Centurion Coal Mining Pty Ltd
t/a Centurion Coal Mine

**Information Request Response
P-EA-100658735 and P-PRCP-100669070_V1**

Centurion Coal Mining Pty Ltd (a subsidiary of Peabody Energy Australia PTY LTD) is seeking authorisation to undertake exploration activities which consist of a pilot coal seam gas (CSG) exploration and extraction programme on Mining Lease (ML) 1790. To obtain authorisation for these activities, an amendment to the Environmental Authority (EA) P-EA-100658735 and Progressive Rehabilitation and Closure Plan (PRCP) P - PRCP - 100669070_V1 is required.

A revised Environmental Authority Amendment Application Supporting Report has been prepared to respond to the IR and be publicised during the public notification period. The below table identifies in which section of the revised report the IR raised have been addressed.

FIGURE 3.2

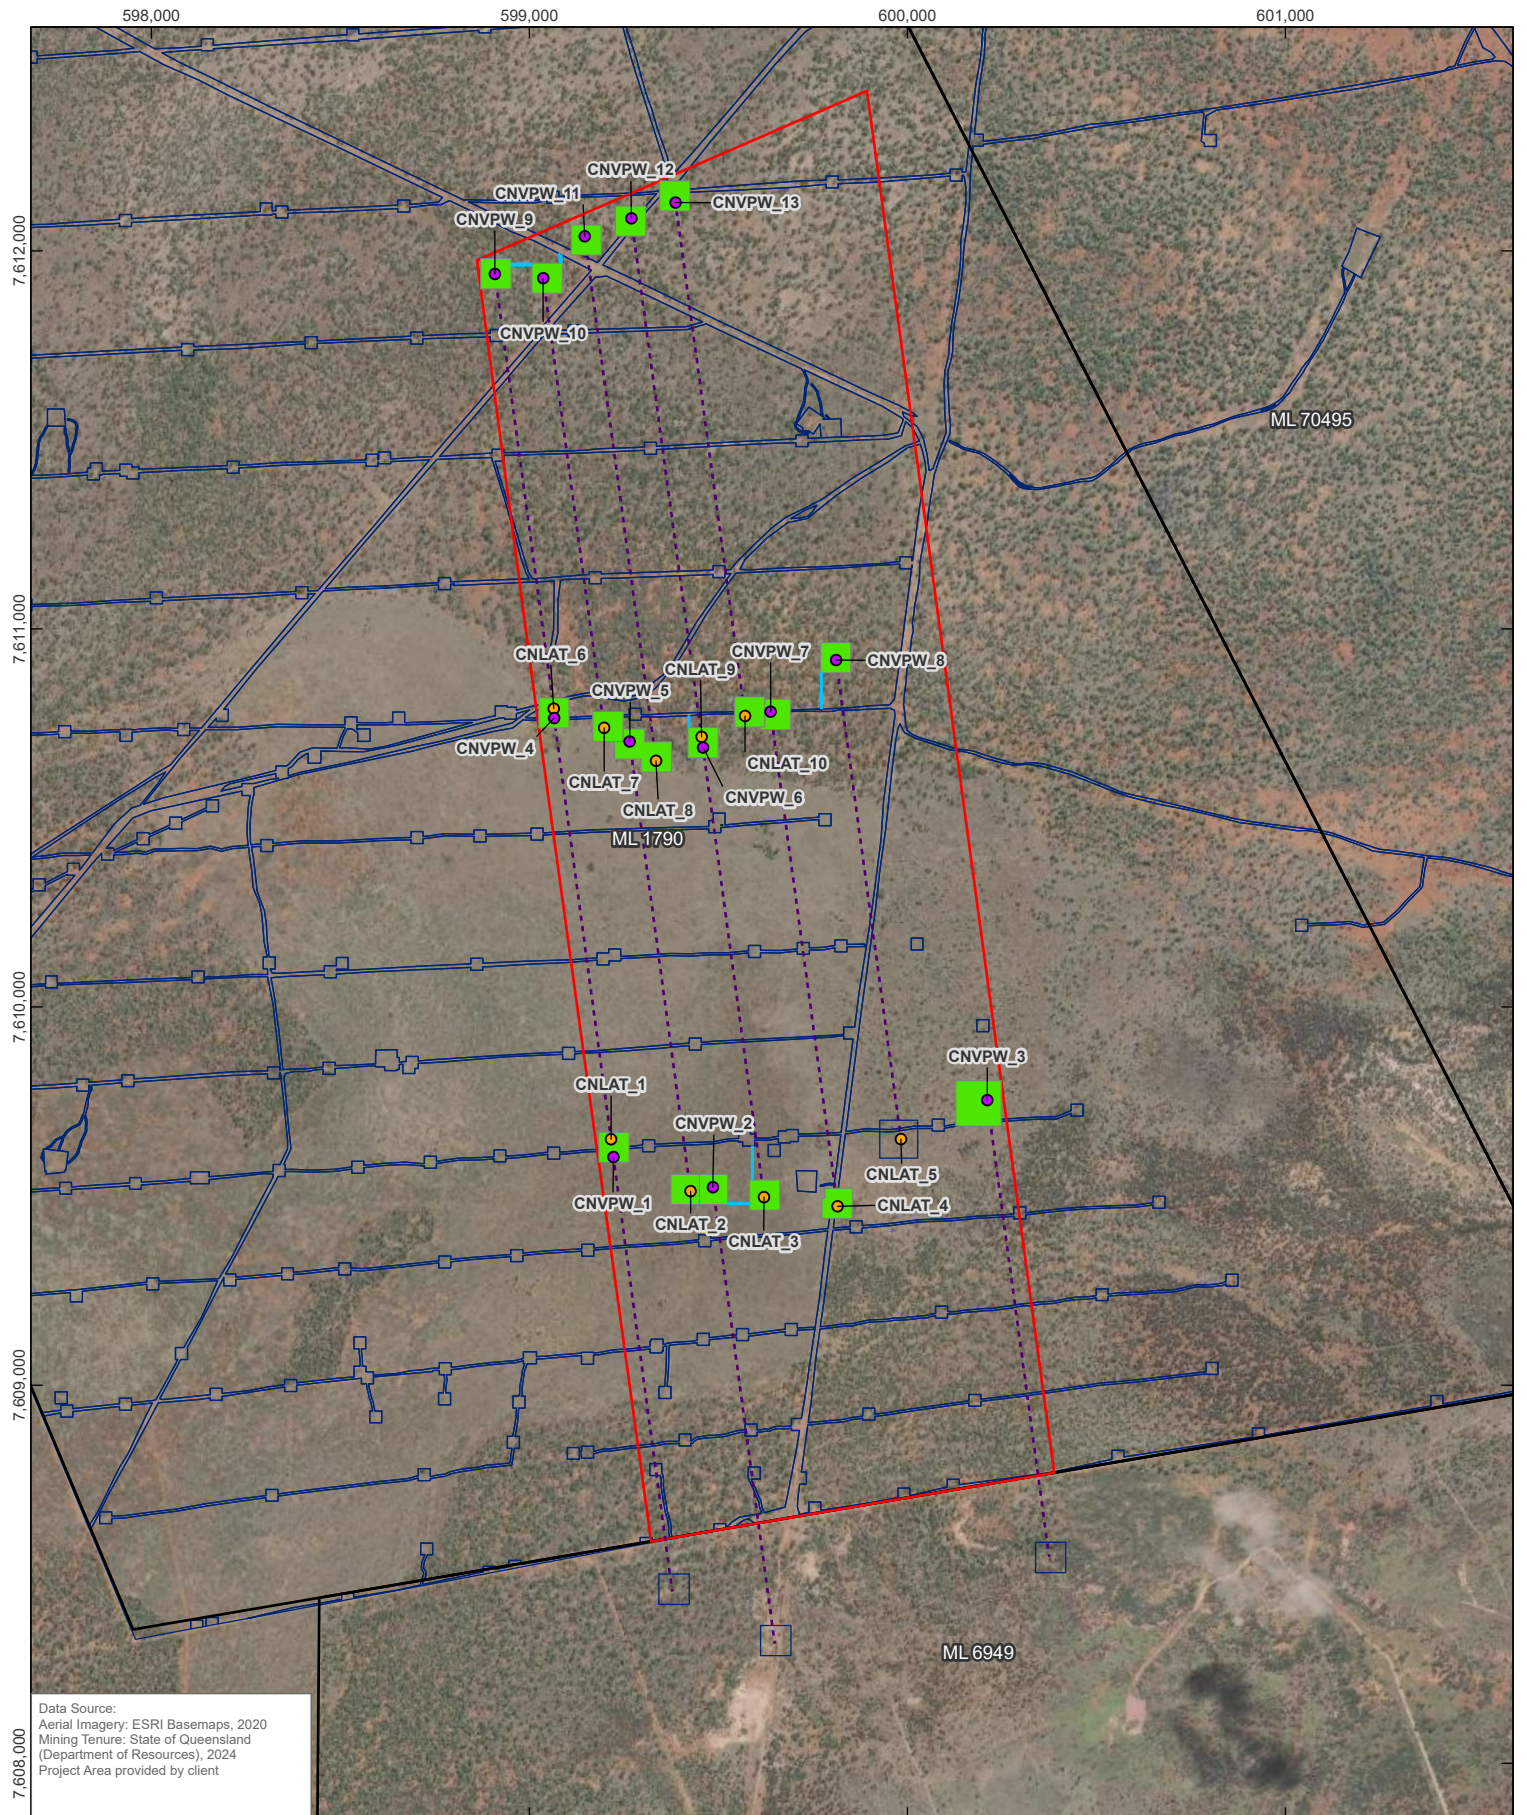
Figure 1 in EA P-EA-100658735 will be updated and replaced by Figure 3.2 of this report.

Existing Condition
<p>Figure 3.2 reflects the following changes to the location and extent of activities for the Project outlined in Section 3 of this report.</p> <ul style="list-style-type: none"> • Clearing 12 ha of vegetation for drill pads (11.80 ha) and 0.31 km of access tracks (0.20 ha). • Drilling, installing and operating thirteen (13) vertical wells and ten (10) lateral wells across 19 drill pads. • Closure and rehabilitation of the wells.
Justification
<p>The proposed amendment ensures that the variation in activities aligns with the approved disturbance and activities outlined in Table 1 (Mining Activities) and Figure 1.</p> <p>The amendment incorporates the Project activities to determine the presence, quantity, and quality of CSG within the GM coal seam and further assess the geological and petrophysical properties of the coal seam (i.e. permeability, porosity).</p>

Existing Condition
<p>Condition F9 would be updated to refer to the drill pads in which the Project activities can be performed.</p> <p>Figure 1 in EA P-EA-100658735 will be updated and replaced by Figure 3.2 of this report. This figure illustrates the location of exploration and mineral development activities.</p>
Justification
<p>The proposed amendment ensures that the variation in activities aligns with the approved disturbance and activities outlined in Table 1 (Mining Activities) and Figures 1 to 4.</p> <p>The amendment incorporates the Project activities to determine the presence, quantity, and quality of CSG within the GM coal seam and further assess the geological and petrophysical properties of the coal seam (i.e. permeability, porosity).</p>

FIGURE 3.3

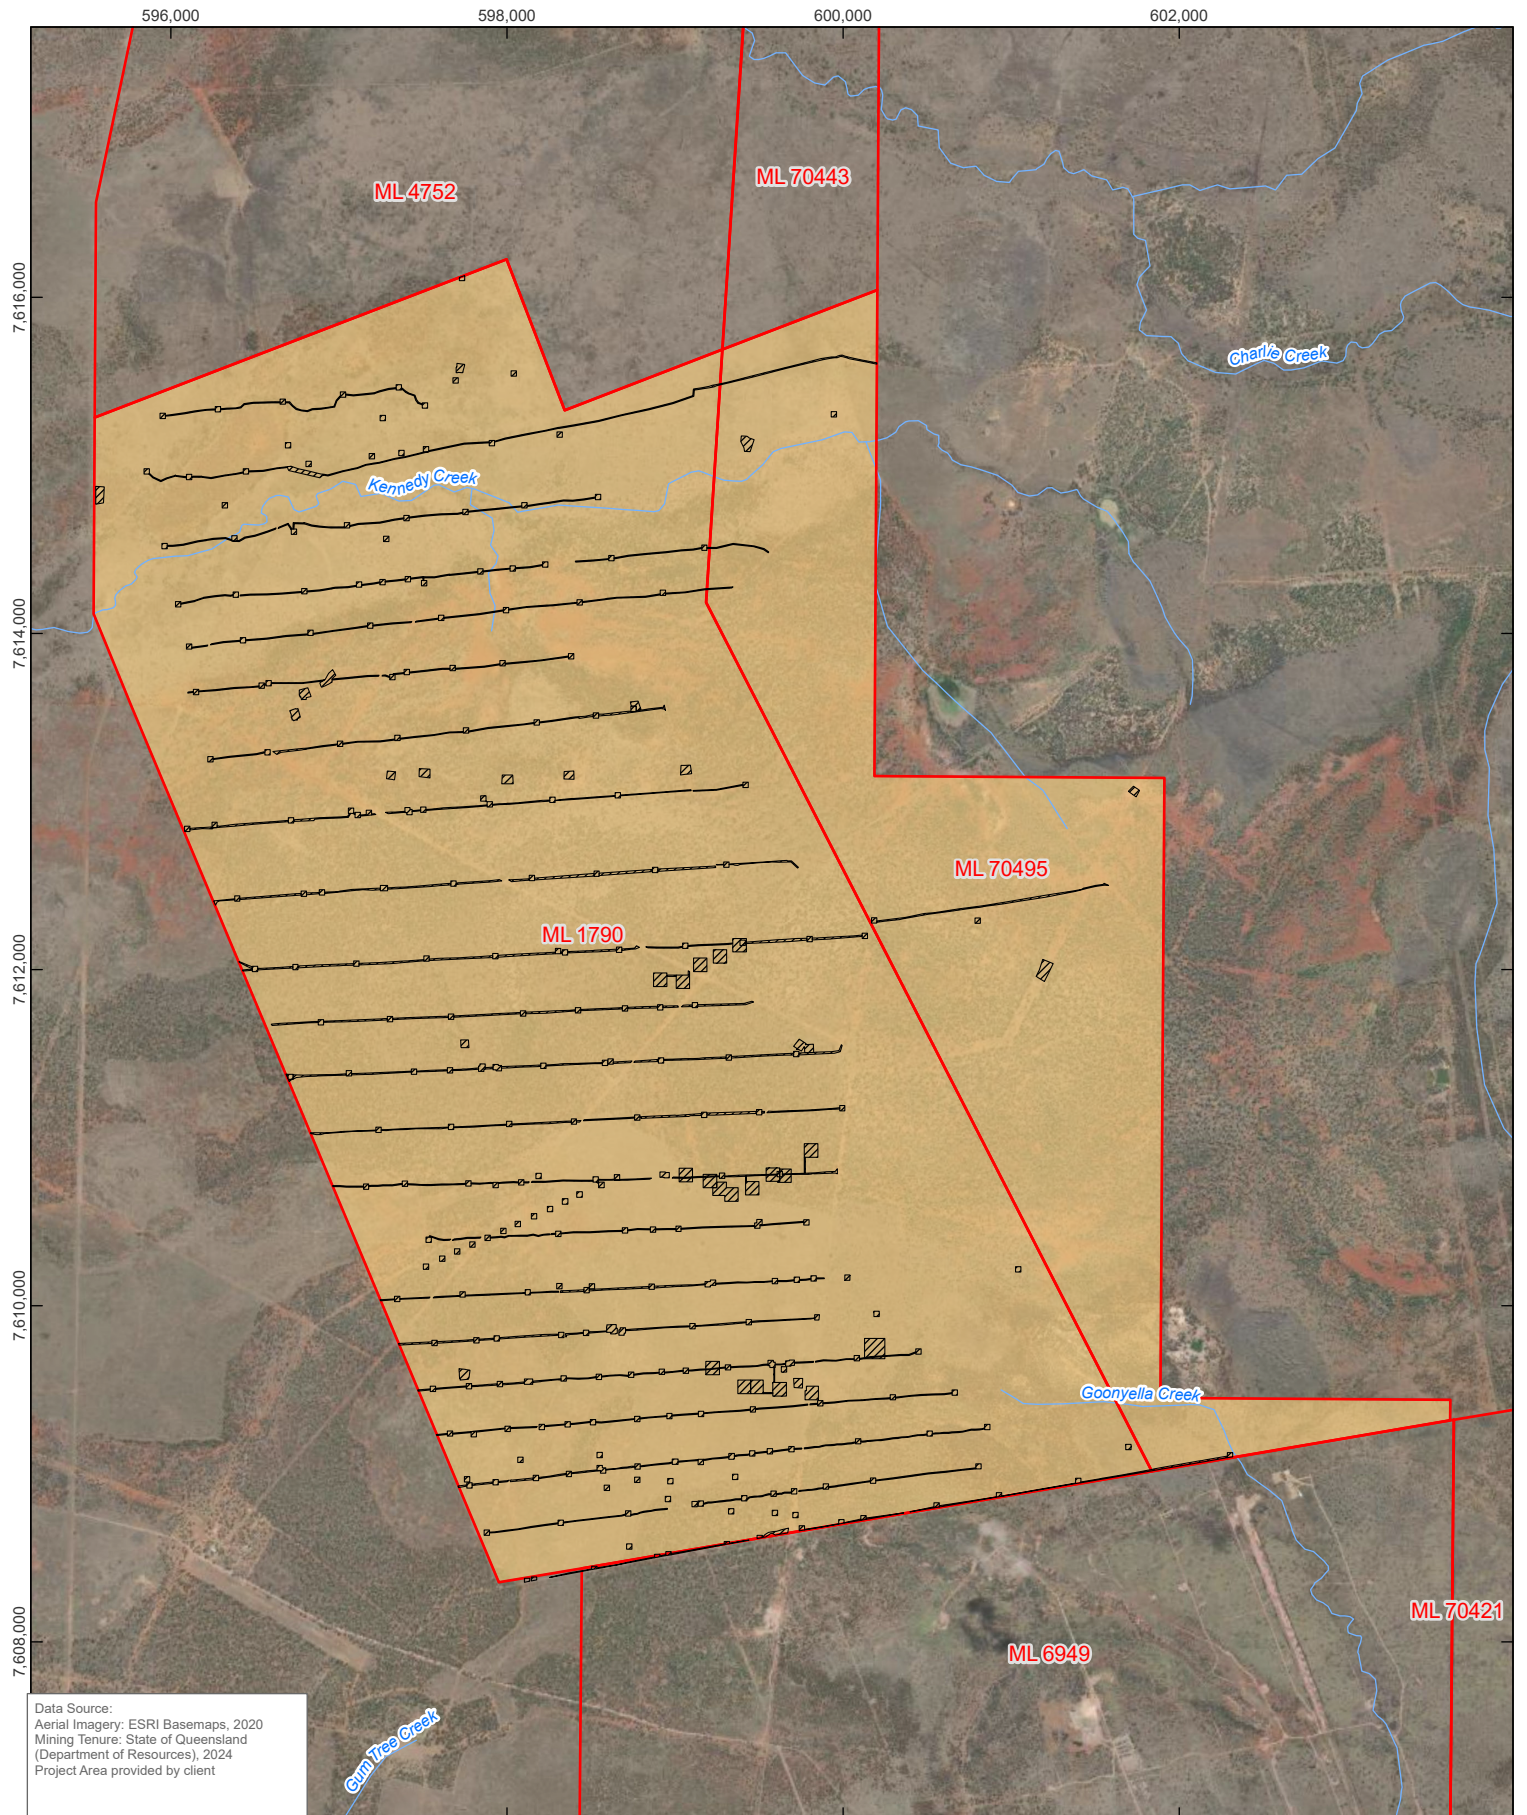
Existing Condition
Section B of the PRCP contains the final site design plans in Figure 1 .
Proposed Condition
No change to wording of condition. Figure 1 referenced in the PRCP is to be amended.
Change
<p>Figure 1 in PRCP P-PRCP-100669070_V1 will be updated and replaced by Figure 3.3 of this report.</p> <p>Figure 3.3 reflects the following changes to the location and extent of activities for the Project activities.</p> <ul style="list-style-type: none"> • Clearing 12 ha of vegetation for drill pads (11.80 ha) and access tracks (0.20 ha) • Developing 0.31 km of 5 m wide access tracks • Drilling, installing and operating thirteen (13) vertical wells and ten (10) lateral wells across 19 drill pads, and • Closure and rehabilitation of the wells.
Justification
The amendment incorporates the Project activities to determine the presence, quantity, and quality of CSG within the GM coal seam and further assess the geological and petrophysical properties of the coal seam (i.e. permeability, porosity).
